Ground Floor Strategy

Consented Scheme

Revised Scheme

Revised Scheme - Eighth Floor Plan

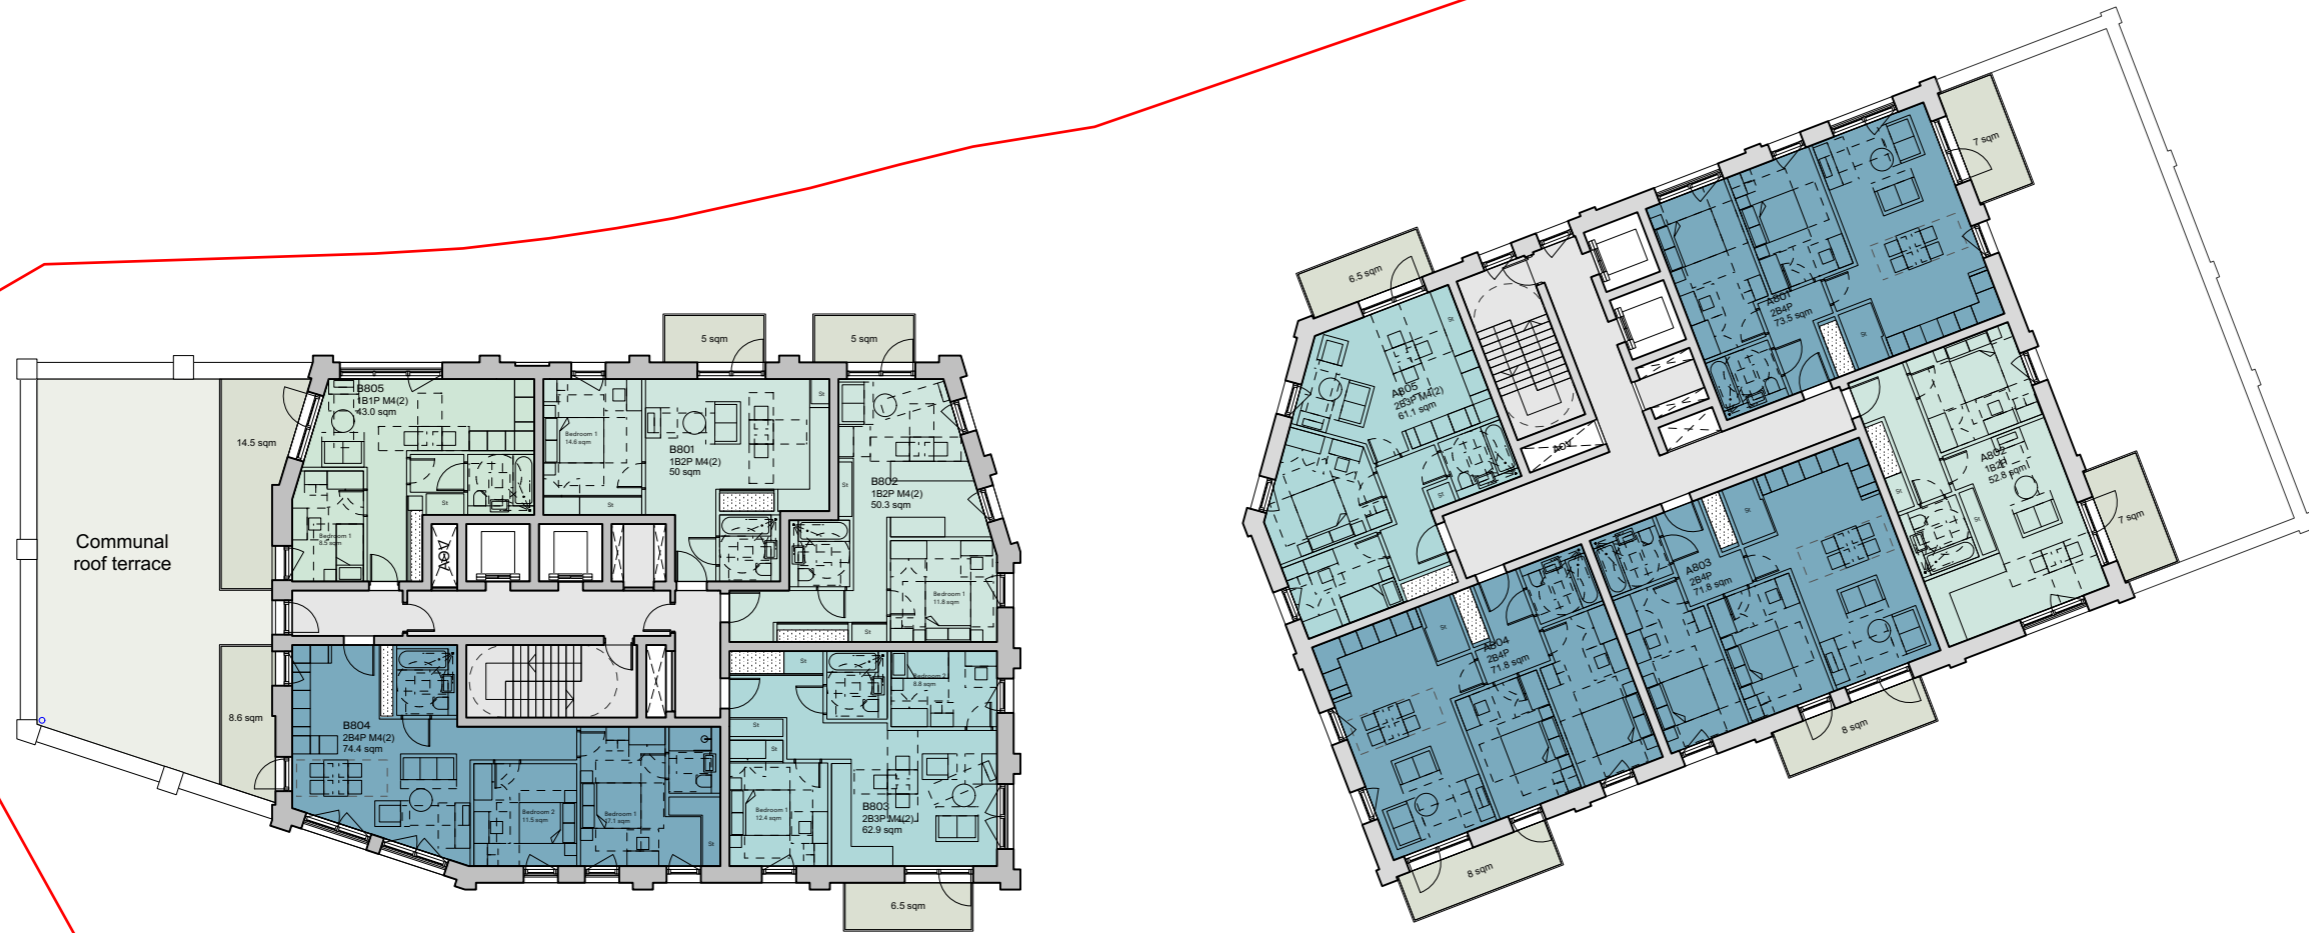
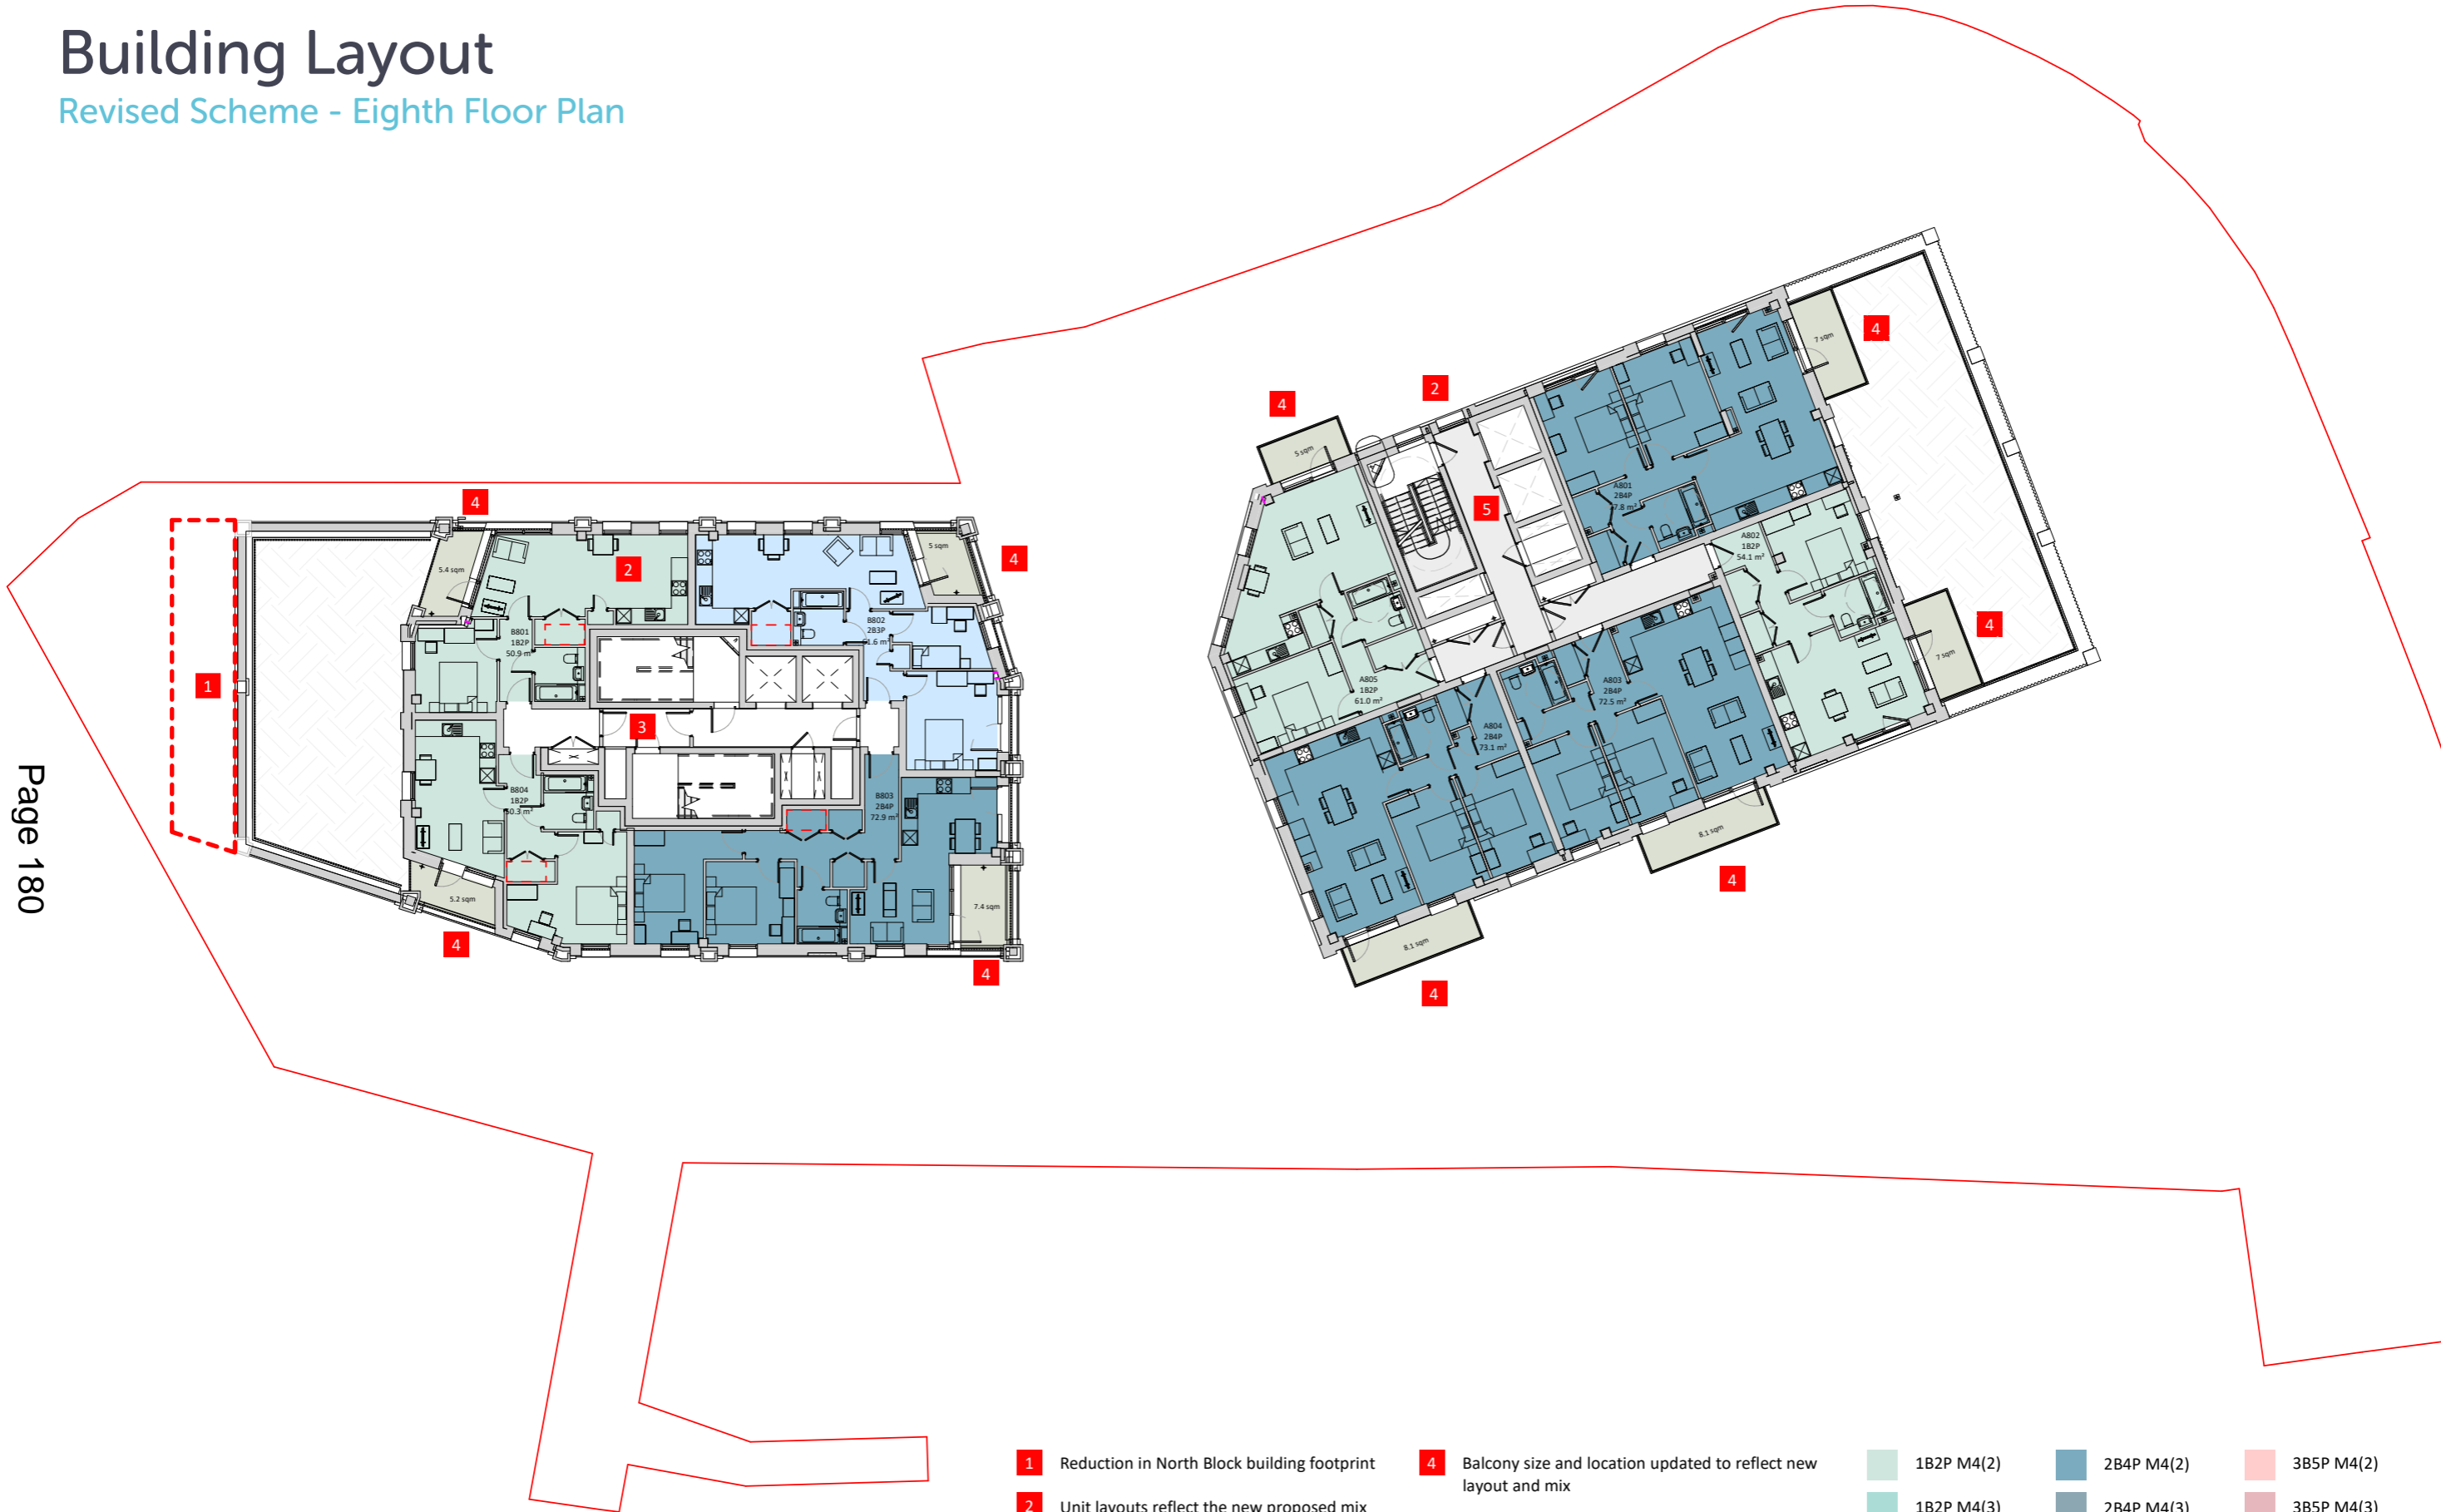
- 1 Reduction in North Block building footprint
 - 2 Unit layouts reflect the new proposed mix
 - 3 Revised core to accommodate secondary escape stair an additional vents and risers

- 4 Balcony size and location updated to reflect new layout and mix
 - 5 Roof Level Plant moved in accordance with below core shift
- | | | |

Revised Scheme - Ninth Floor Plan

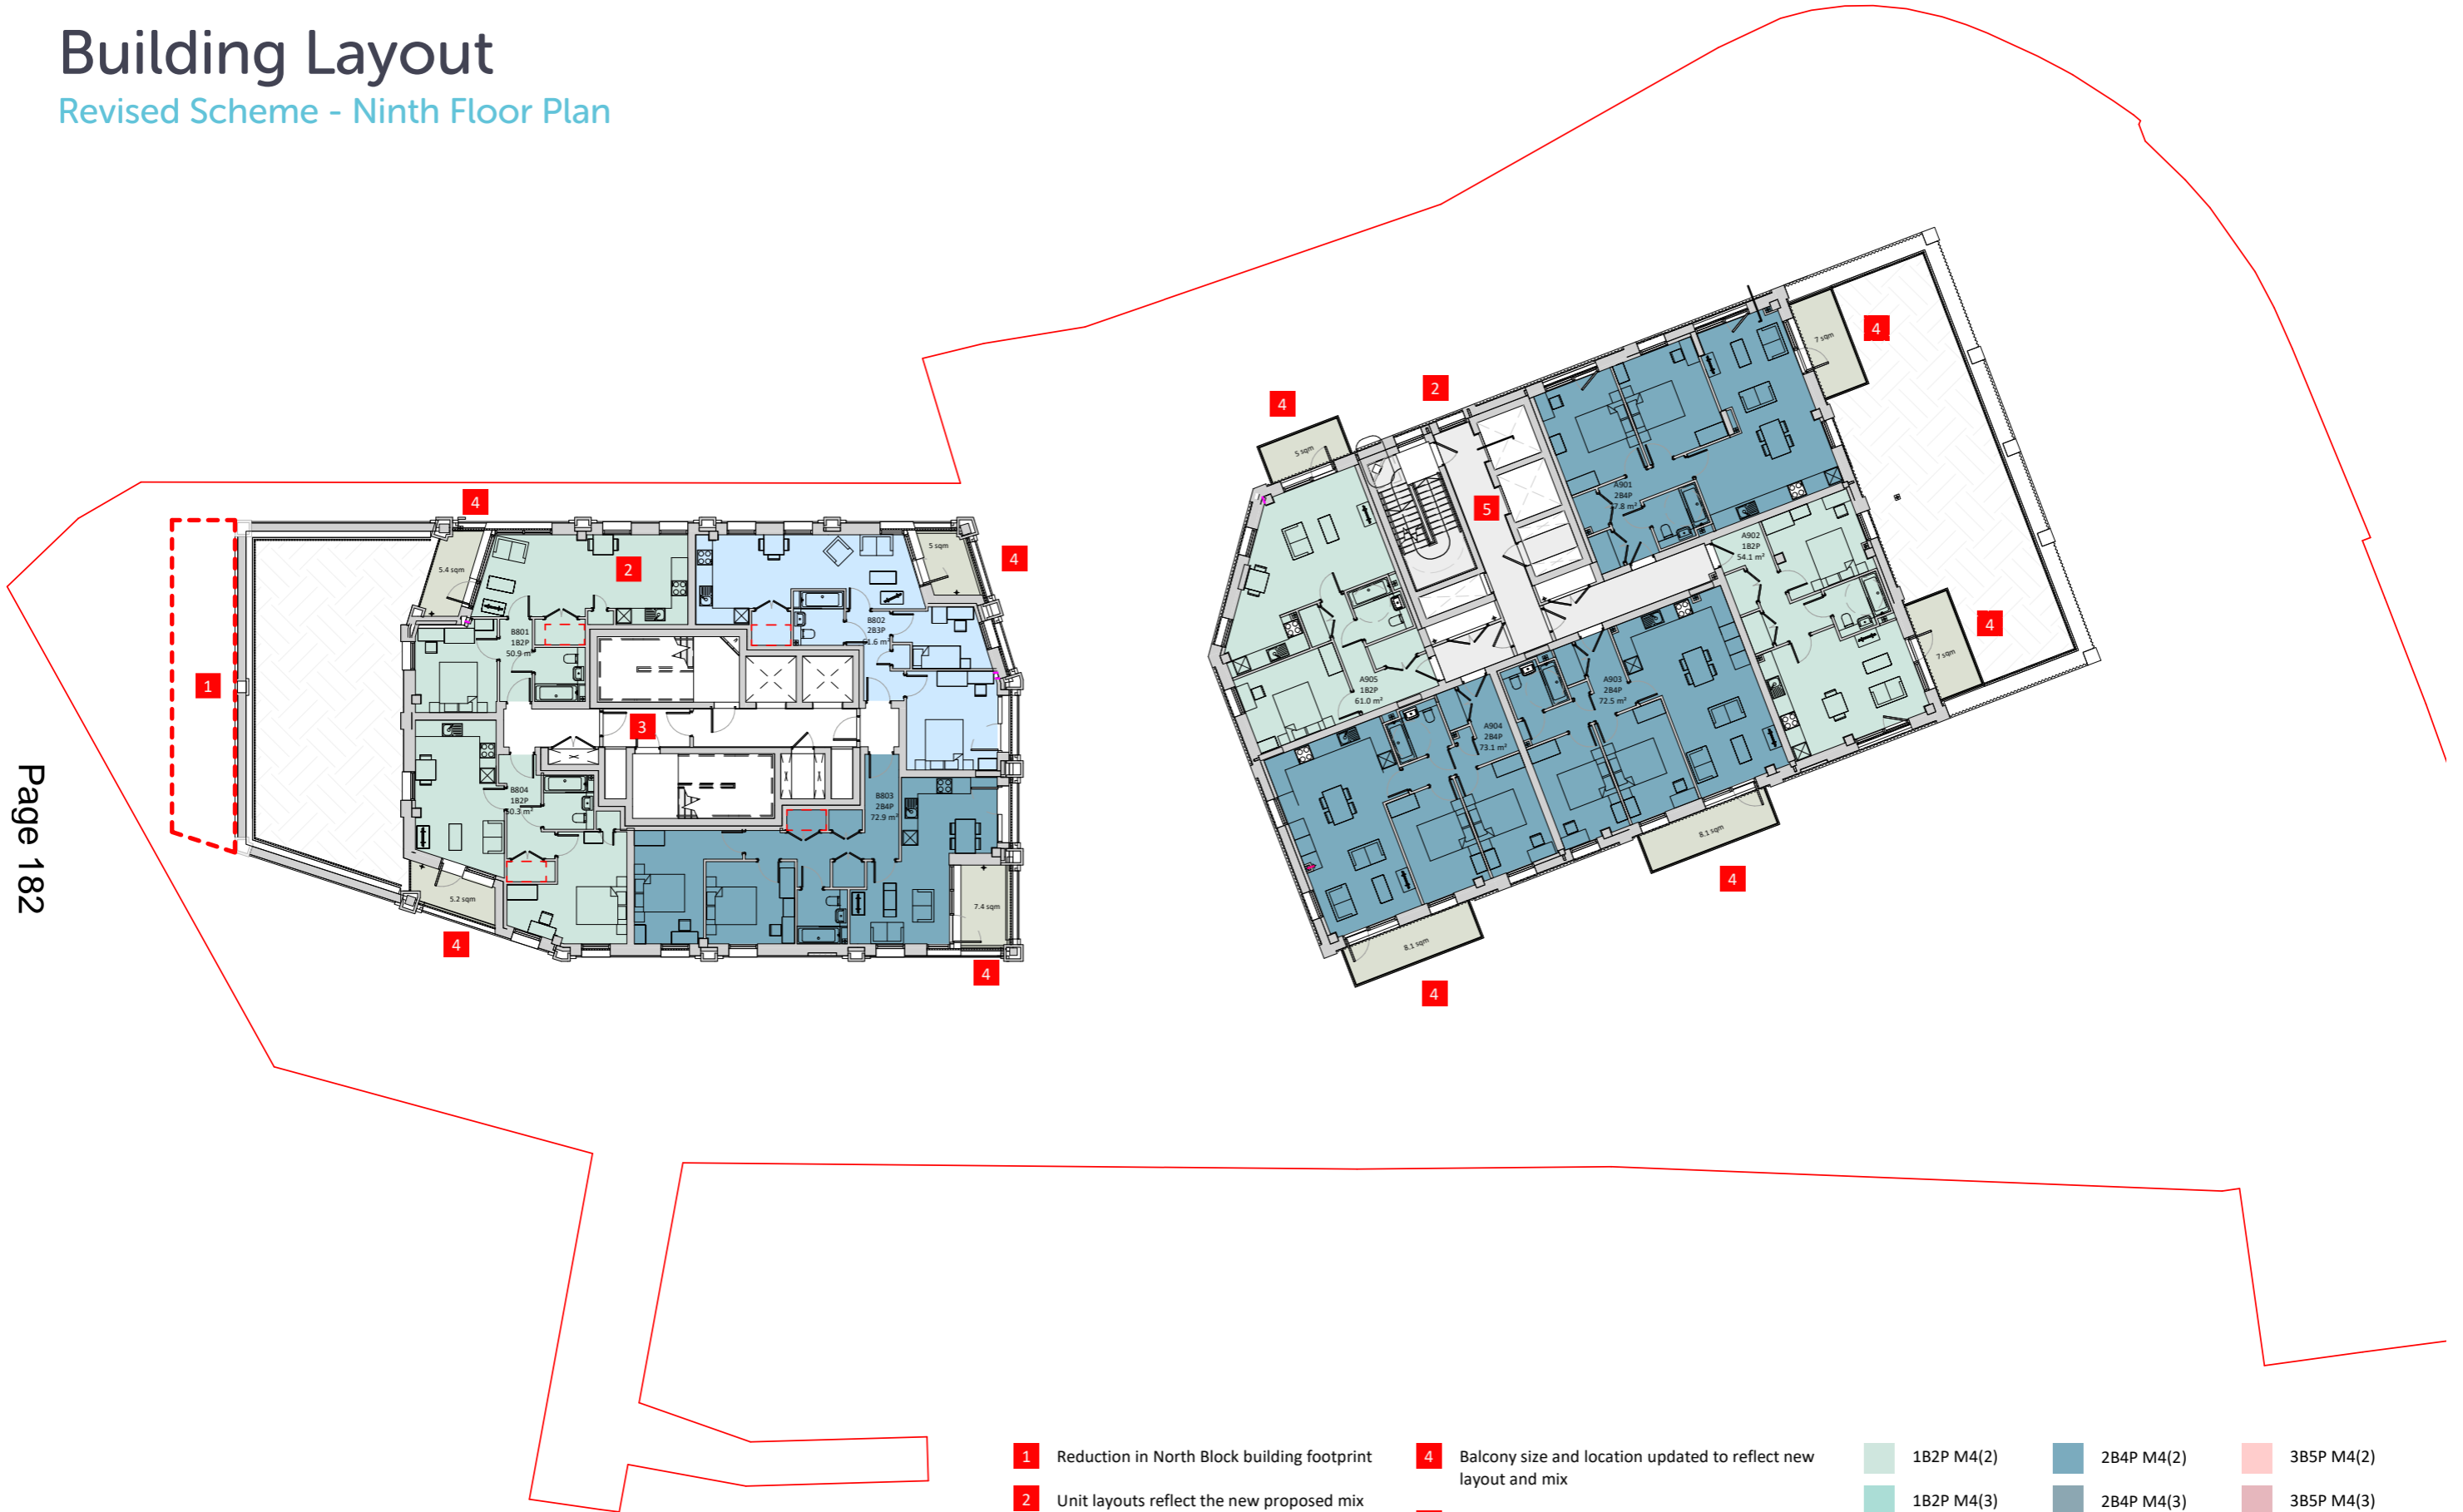
- 1 Reduction in North Block building footprint
 - 2 Unit layouts reflect the new proposed mix
 - 3 Revised core to accommodate secondary escape stair an additional vents and risers

- 4 Balcony size and location updated to reflect new layout and mix
 - 5 Roof Level Plant moved in accordance with below core shift
- | | | | | | |
